DEPARTMENT OF VETERANS AFFAIRS
Veterans Health Administration
National Health Physics Program (NHPP)
2200 Fort Roots Drive
North Little Rock, AR 72114

Re: NRC License 03-23853-01VA

Memorandum

Subj: VHA Permit Number 04-23242-01

Veterans Administration Medical Center, Palo Alto, CA Sanitary Sewer Drawing, May 1988

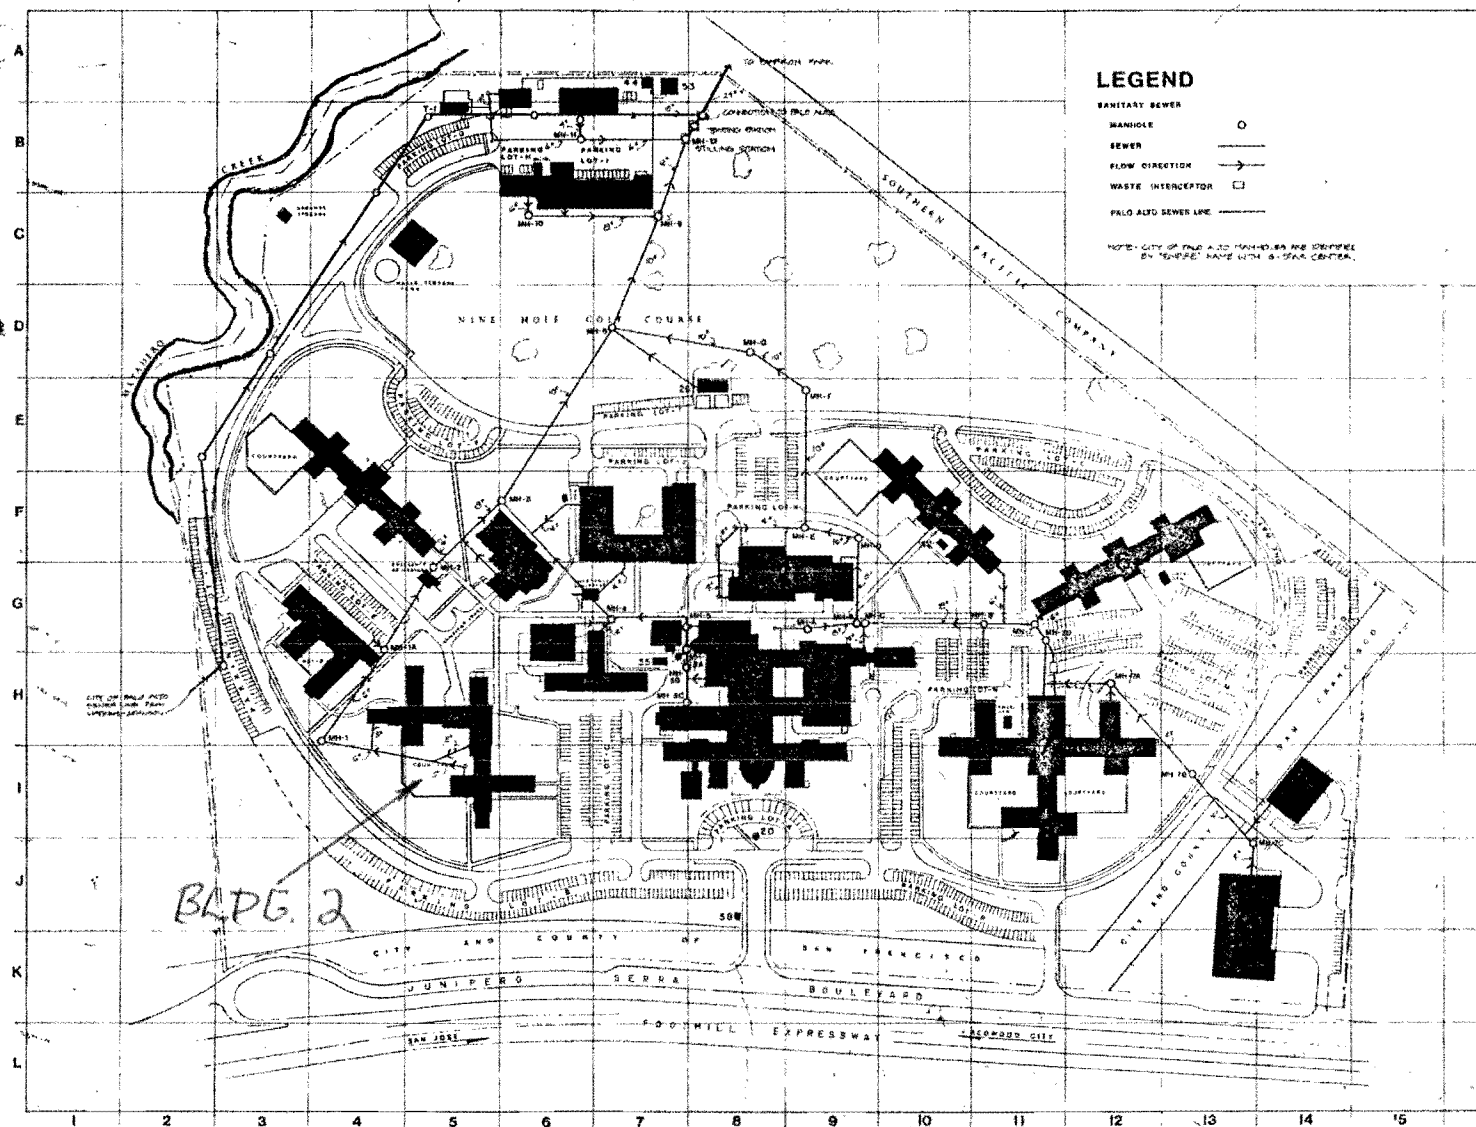
Documentation (i.e., facility diagrams) of the sanitary sewer system to show the system as it was during times when radioactive materials were used as compared to current state (maybe there have been no changes) and indicating no holdup tanks. NRC reviewer would prefer to have some documentation of the sewer system as compared to verbal statements.

I am including as Attachments 3 and 4 drawings from 1988 and 1992 showing the layout of the sewer lines at the VA Palo Alto facility. The drawings do not show any hold-up tanks and show a direct sewer lines to Bldg. 2. According to Engineering this has not changed throughout the life of Building 2 and is still the same today.
